|  | Information technique Technical information Información técnica | Document n° NT 76-01 |
| Sujet: vérification étoile de sélection 250/300 SE-(R) Subject: verification of 250/300 SE-(R) shift drum locator Asunto: verificación estrella selectora 250/300 SE-(R) | | Date/Fecha 02/06/2014 |

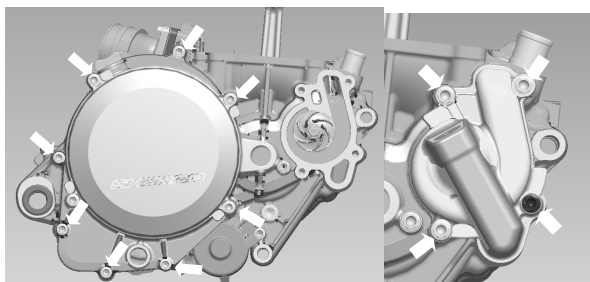
Due to a manufacturing defect by the supplier, it is possible for the steel needles [1] from the shift drum locator ref 3811 to come out [2] and damage the engine. We ask you to complete the following procedure to replace the star. 1:30 hours of labor is allowed and the necessary parts required are also covered.

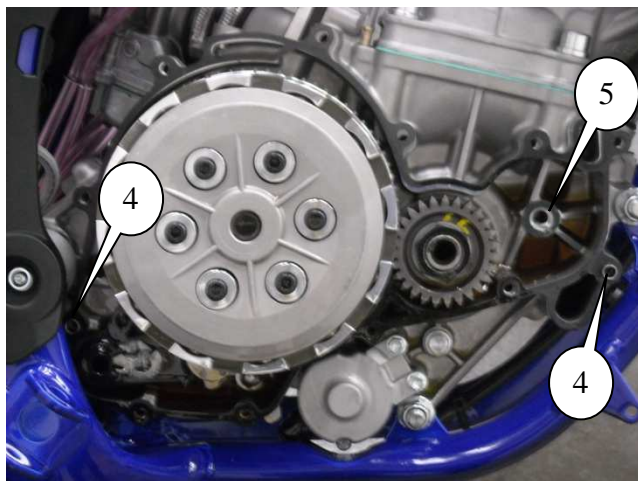
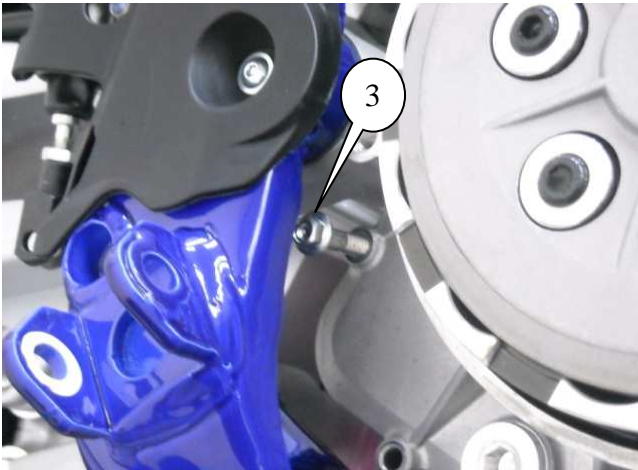
- Dismount the exhaust pipe.
- Servicing the cooling system (see owner's manual)
- Drain the engine oil (see the manual for details)
- Dismount the rear brake pedal.
- Remove the clutch inner cover. To dismount the crankcase on the frame, only unscrew the screw [3] and don't remove it. Remove all the other M6 screws.
- Dismount the clutch inner cover.

Be careful with the two dowels [4] and water pump washer [5]

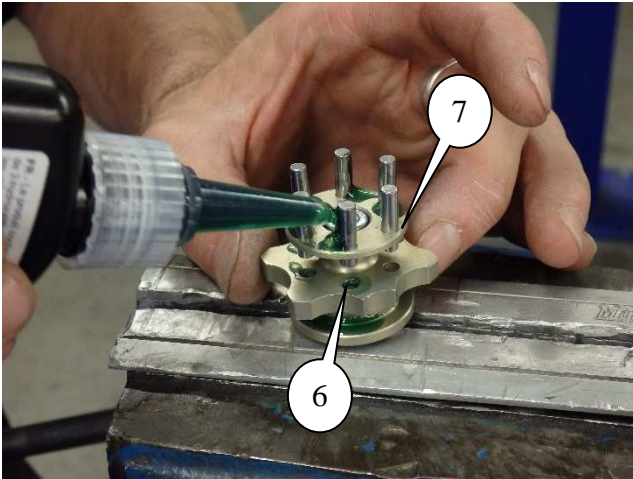
- Using a pair of cutting pliers, pry the needles and make sure that they do not come out.

- If the needles are loose and come out, degrease them with a degreaser (Minerva brake cleaner and degreaser)
- Use compressed air and blow the assembly clean and dry

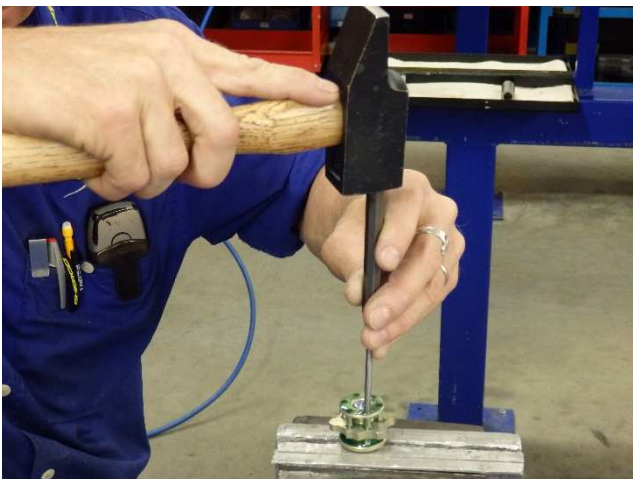
- Apply strong thread locker to the bottom (6) of the base and to the needles (7).

- Insert the needles with a punch. Verify that they do not protrude above the aluminum part
- Clean off any excess threadlocker
- Wait for the product to take effect (minimum 2 hours)
- Check the star to make sure that the needles remain in place.
